**Beaver Dam Mine Project
Responses to the Information Request, Round 2
October 2021**

**Submitted to the Impact Assessment Agency of Canada
and Nova Scotia Environment**

Beaver Dam Mine Project Environmental Impact Assessment
 Information Request Responses, Round 2

FIGURE CEA 2-05-1

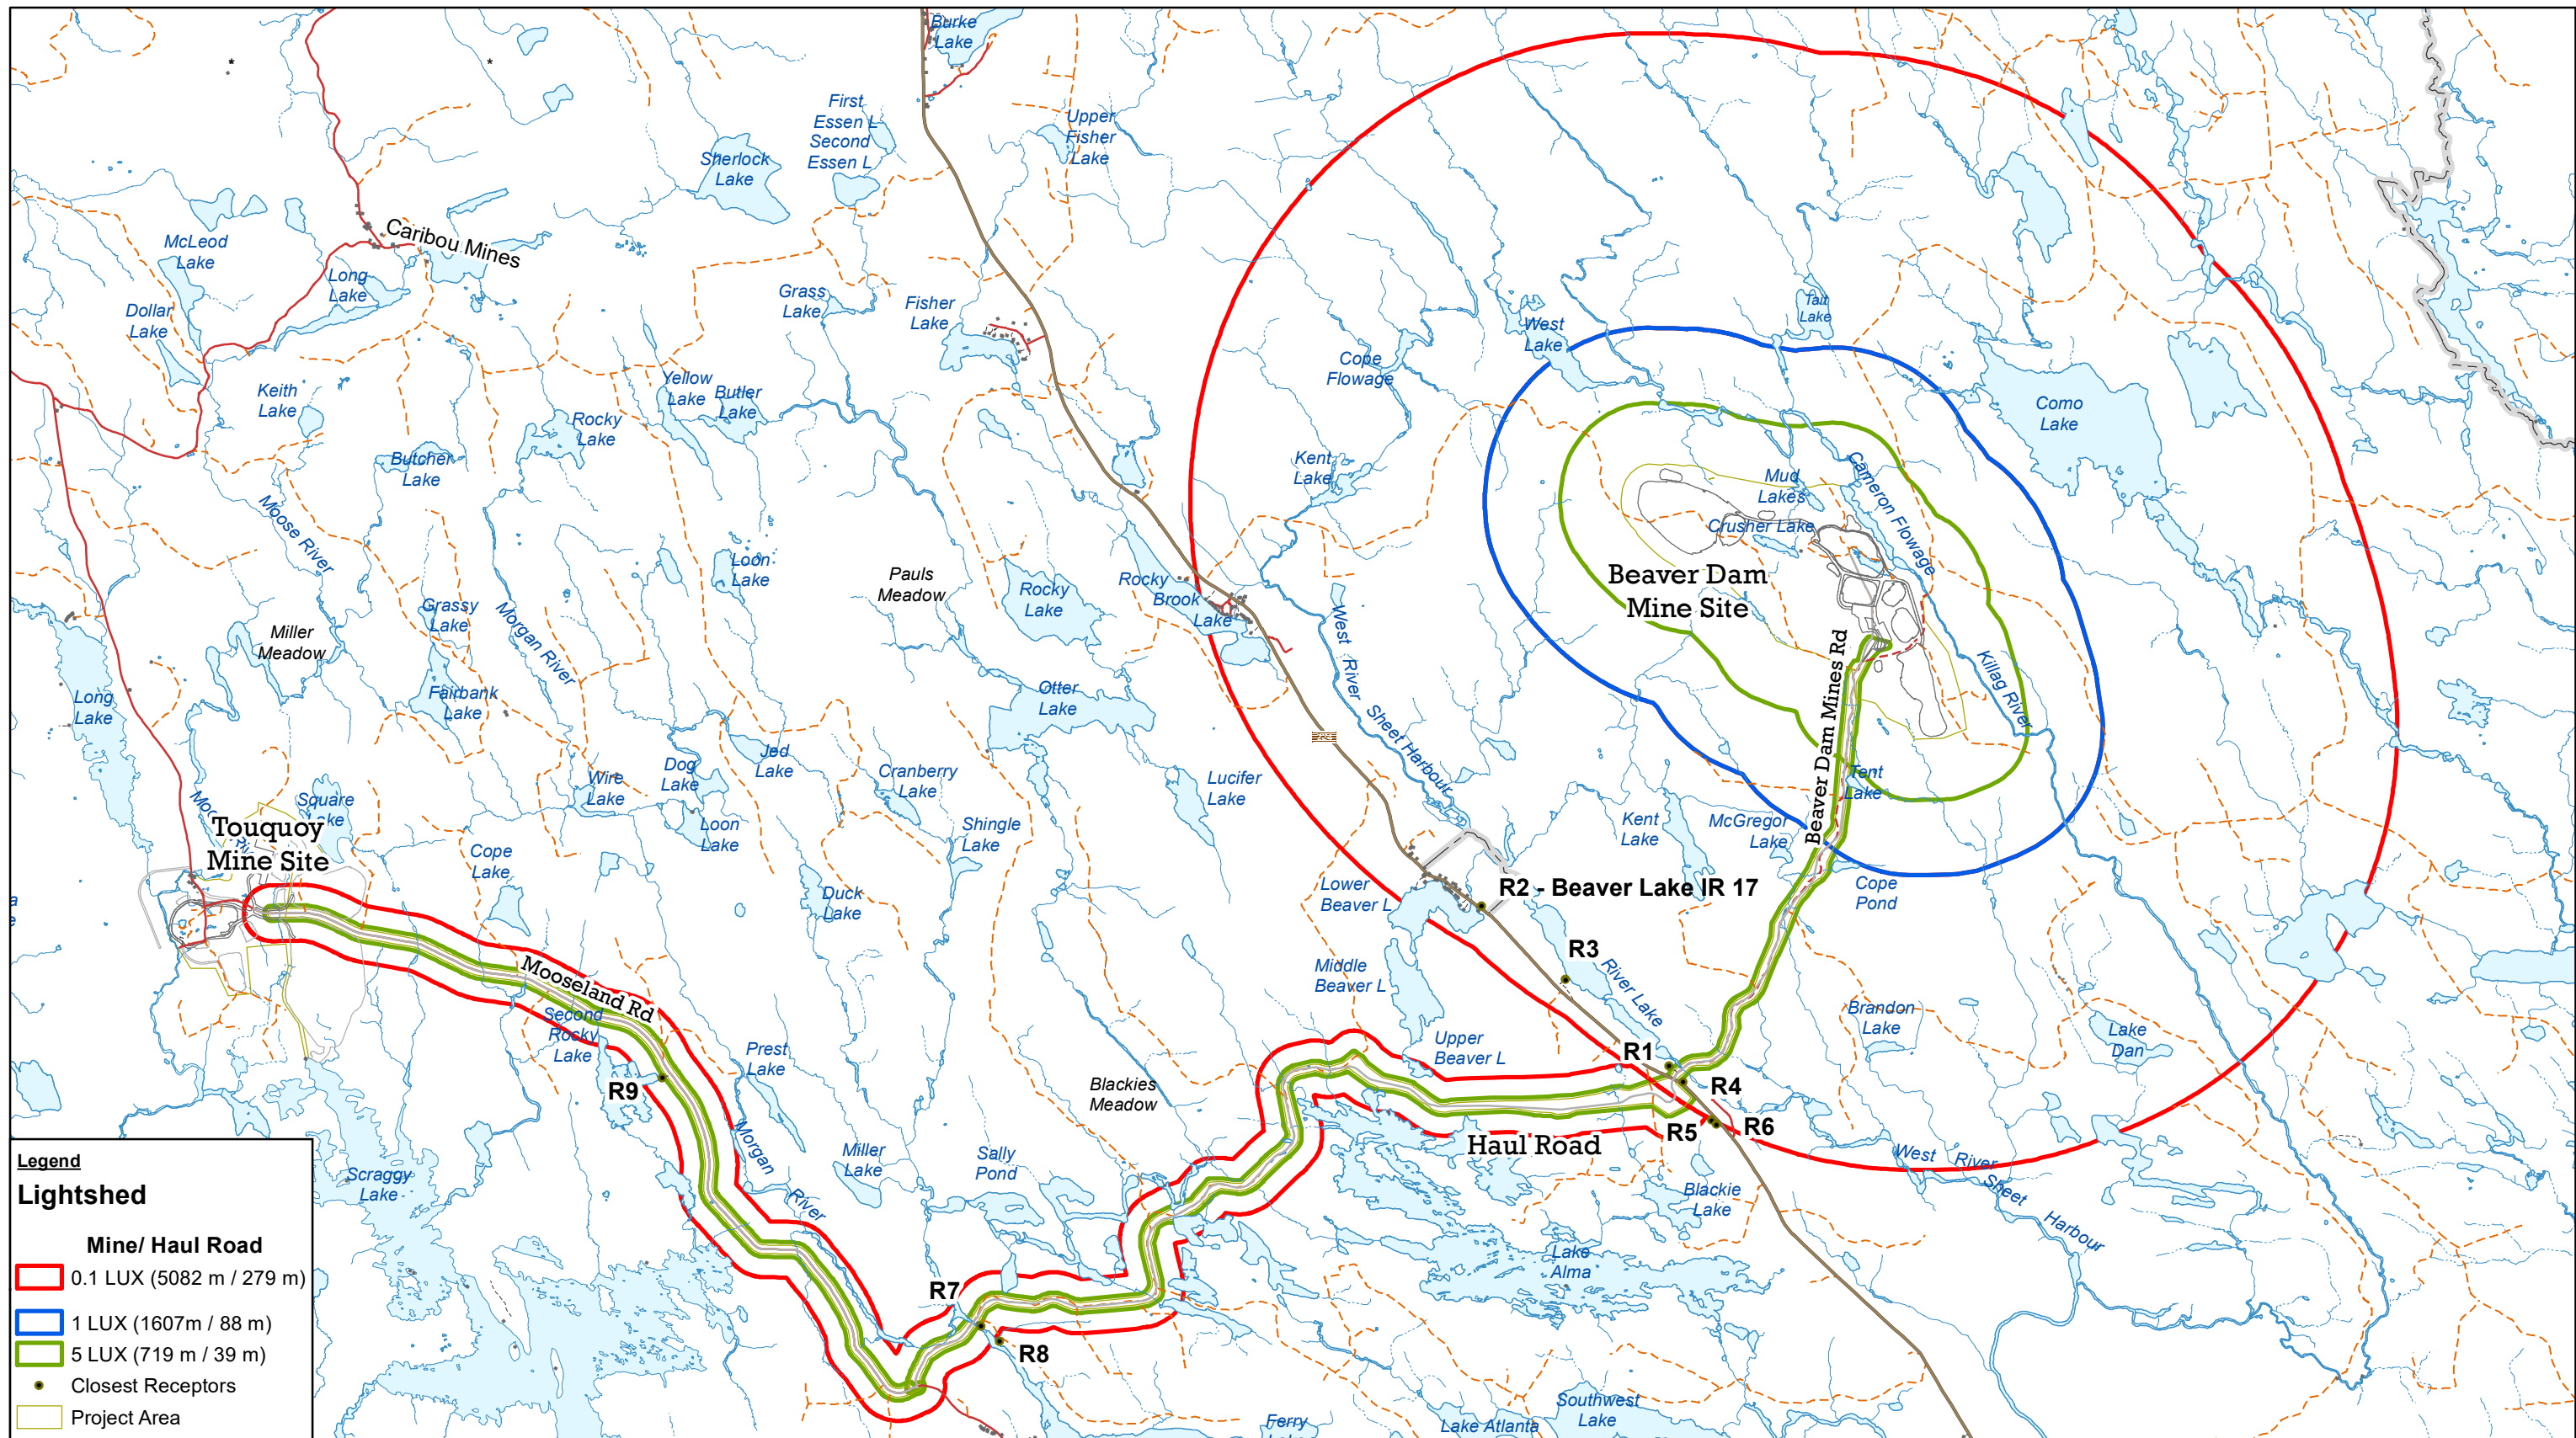
Provide a light shed map in consideration of Beaver Dam IR 17 and areas identified for current use practices. The model should use a conservative value in estimating moisture or particulate matter in the atmosphere.

A light shed map has been provided as Section 6.3.7, Figure 6.3-2, page 6-104 of the Updated 2021 EIS (AMNS 2021) and provided as Figure CEAA 2-05-1 in response to this Information Request (CEAA 2-05).
